MAHONING HYDROELECTRIC PROJECT

FERC NO. 12555

RECREATION AND AESTHETICS PLAN

**APPENDIX C
CONSULTATION DOCUMENTATION**

Photo 3-1. View of the Southern Shore Before and Proposed After Construction

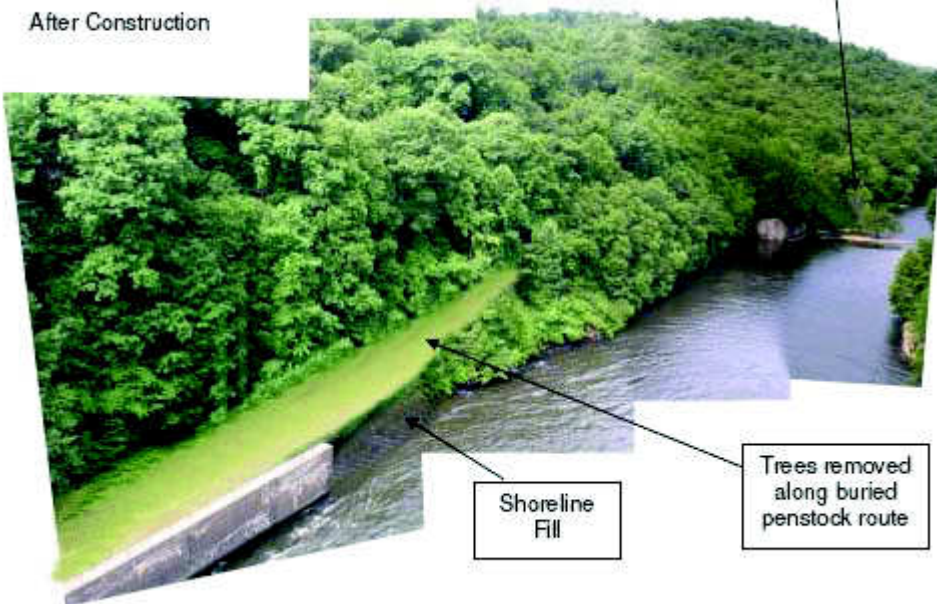
To limit the visual impact from project structures, the penstock will be buried and vegetated with native plantings, as shown in Photo 3-1. The powerhouse will be designed and constructed to blend in with the existing environment, in particular in keeping with the existing USACE structures and architecture, as shown in Photo 3-2. Powerhouse walls that are visible from the north bank will be contoured using a concrete form (Duraform # 12003 New England Drystack has been selected) and the stained in a color (TBD) to complement the natural rock in the vicinity. Plantings around the power house will be of native species. MCHC will propose adding visual buffers, such as rock piles as appropriate to the USACE for any structures still deemed to be not in keeping with the existing visual environment.

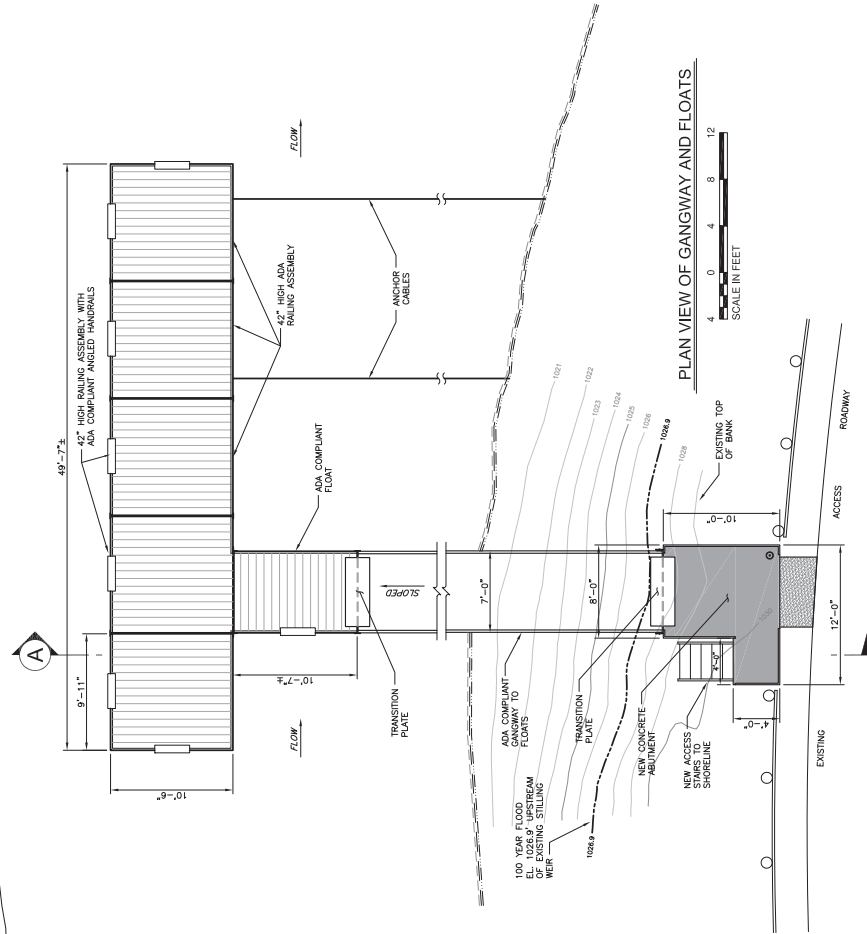
6	USACE	<p>The narrative includes a reference to “steps leading from the pier access ramp to the shore for improved shoreline access” but this feature is not shown on Drawing 1. As has been mentioned in previous meetings, we encourage the construction of additional steps or grouted walkways through the riprap along the banks of the stilling pool to enhance angler access.</p>	<p>This feature is shown on updated drawings provided in the Plan in Appendix A.</p>

Agency	Comment	Response
7	USACE	The narrative also mentions the installation of fish attraction structures, but again these are not indicated on Drawing 1. We support this concept but will need to review details to assure that they will not affect the hydraulic characteristics of the stilling pool.	These features are shown on updated drawings provided in the Plan in Appendix A and consist of 4 ft by 4 ft by 4 ft boulders placed approximately 15 to 20 ft from the southern shore, approximately 40 ft apart, as preferred by PFBC and USACE.
8	USACE	Installation of solar lighting in the middle of the pier has been discussed in the past. This would be a nice amenity for the fishermen, but it is not shown on the drawing or mentioned in the narrative. Is this still part of the plan?	This feature is shown on updated drawings provided in the Plan.
9	USACE	Installation of a few angled arm rests on the railings in locations that would be of use to anglers seated in wheelchairs would be a benefit.	This feature has been added and is shown on updated drawings provided in the Plan.

2. The narrative includes a reference to “steps leading from the pier access ramp to the shore for improved shoreline access” but this feature is not shown on Drawing 1. As has been mentioned in previous meetings, we encourage the construction of additional steps or grouted walkways through the riprap along the banks of the stilling pool to enhance angler access.

3. The narrative also mentions the installation of fish attraction structures, but again these are not indicated on Drawing 1. We support this concept but will need to review details to assure that they will not affect the hydraulic characteristics of the stilling pool.

Photo 2. Undefined path with four foot high bank downstream of Stilling basin headwall and stairway.

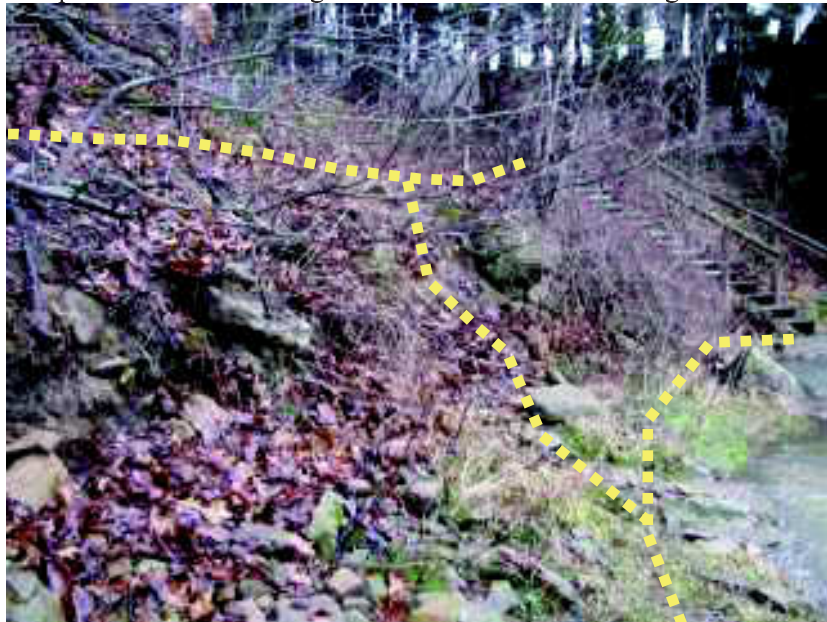
1. Definition of a path in one of three locations downstream of the steps (Photo 2) to eliminate or improve a portion of the path that contains a steep four foot bank.
2. General path improvement by moving rocks and sections of fallen trees that impede travel, including pruning interfering vegetation in an approximate four foot width. We envision use of manual labor and hand tools for this work, including chain saws for removing sections of downed trees to improve ease of travel. In general, the path travels above the high water mark where herbaceous vegetation and shrubs transition to upland vegetation (Photo 3).
3. Enhancing the path around a large slanted boulder that reaches to the water's edge under high flow conditions (Photo 4). The rock was slippery on the date of the visit.
